Service Bulletin

Bulletin No.: 23-NA-020

Subject: Oil Leak from Front of Engine

Brand:	Model:	Model Year:		VIN:		Engine:	Transmission:
		from	to	from	to		
Chevrolet	Corvette	2023	2023	—	—	5.5L (RPO LT6)	—

6002788

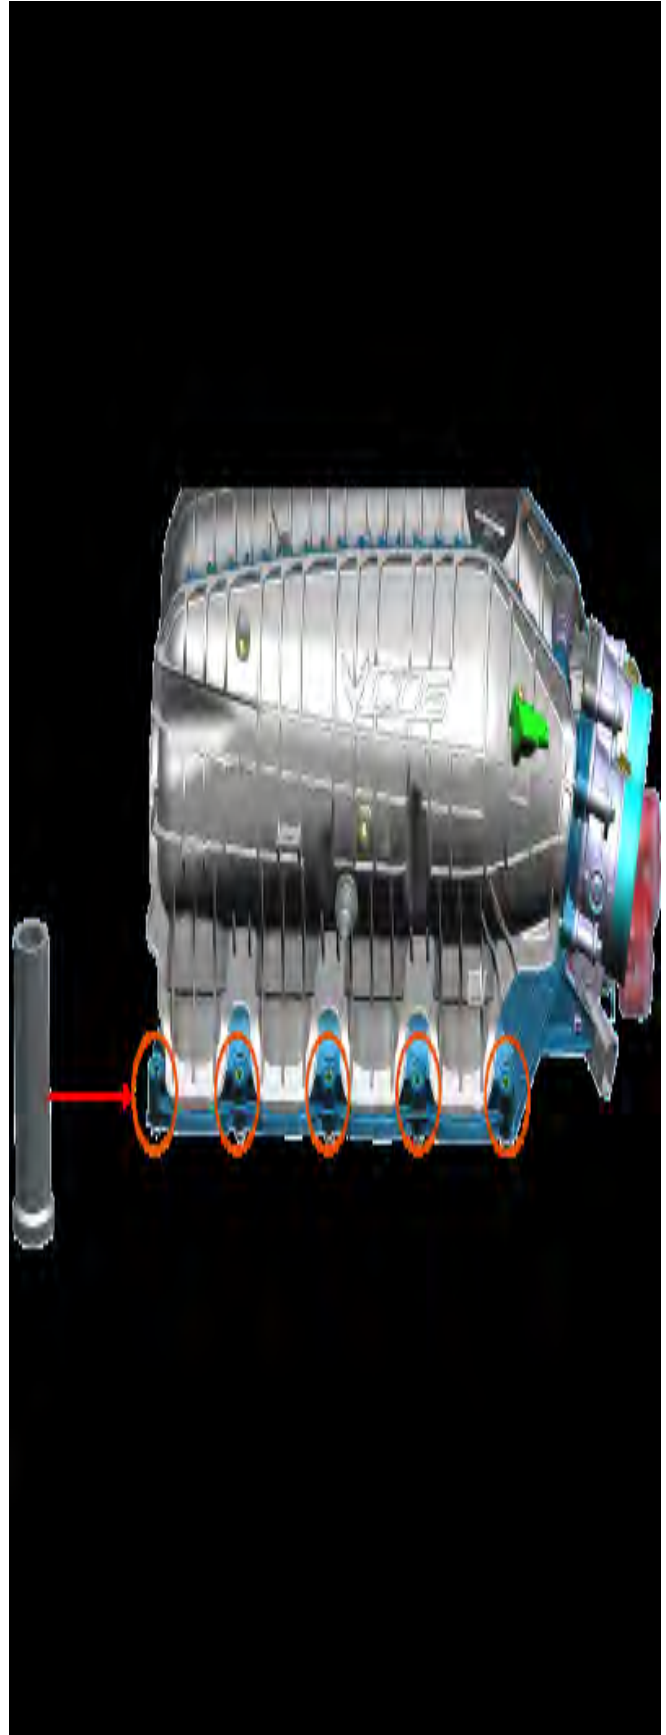
Important: Application of the RTV has changed. Please refer to the picture and steps below for proper RTV application.

Note: The sealing surface must be clean and free of contaminants prior to applying the RTV sealant. Do not touch the sealing surface once it has been cleaned.

1. Clean the sealing surface at the T-Joints (1 and 2) with low VOC brake cleaner, then wipe dry with a clean lint-free cloth.

Note: Do not allow RTV to skin over. The engine front cover gaskets and engine front cover must be installed within 8 minutes of RTV application.

2. Apply a 5 mm wide x 15 mm bead of sealant to the 4 T-Joints (1) between the cylinder head-to-engine block and the engine block-to-lower crankcase.
3. Apply a 5 mm wide x 25 mm bead of sealant to the 2 T-Joints (2) between the cylinder head-to-engine block and the engine block-to-lower crankcase.

Intake Assembly left hand side shown (right side similar).

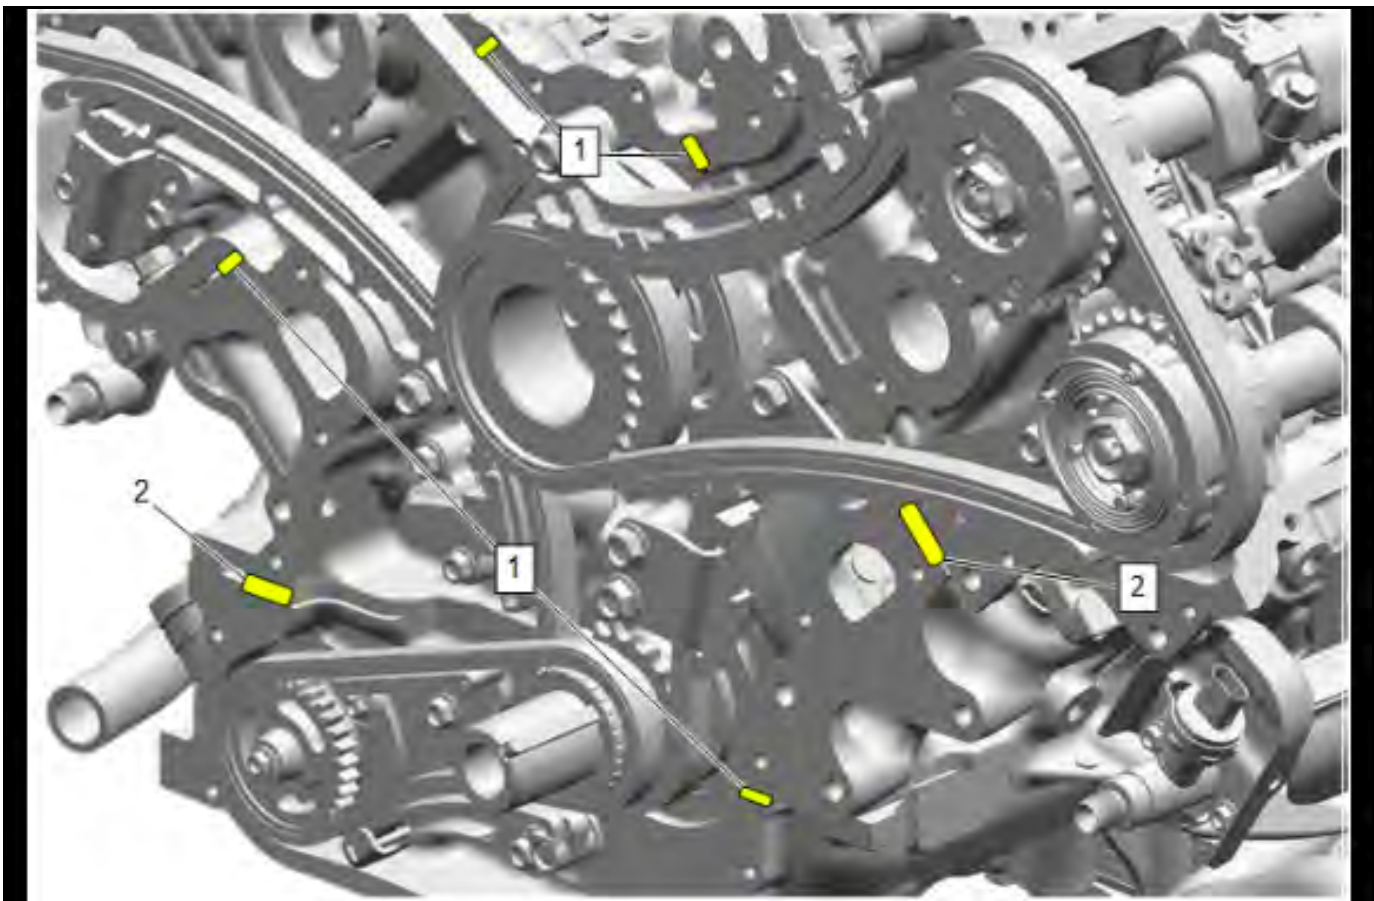
Important: When performing this service procedure, the intake manifold needs to be removed and reinstalled. During installation, ensure that all 10 compression limiters are installed and present in their correct positions before fastening the intake to the cylinder head.
